Technical Bulletin

Subject: Exterior Rear View Mirror, Wind Noise Above 50 MPH

Number: 05-01

Model(s): Touareg

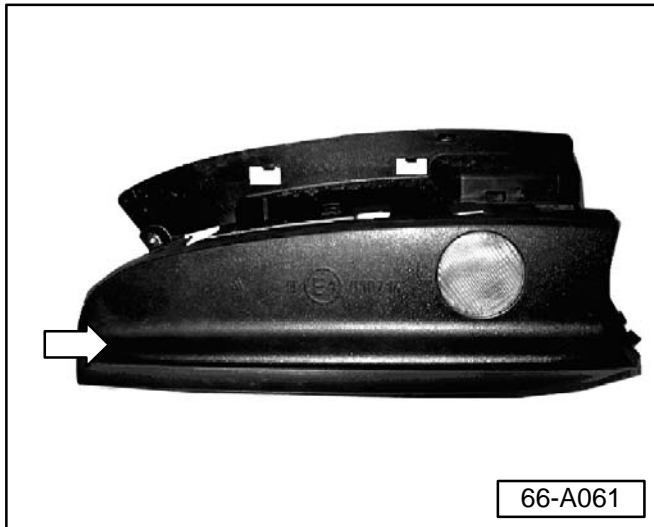
Improved exterior mirror housing lower trim as of VIN: 7L_4D071917.

◀ The improved housing trim has a spoiler added to the trim surface facing down when installed.

Install new left and right lower mirror housing trims.

◀ – Apply felt to inside lower edge of housing as shown.

◆ Felt must NOT be visible when housing is reassembled.
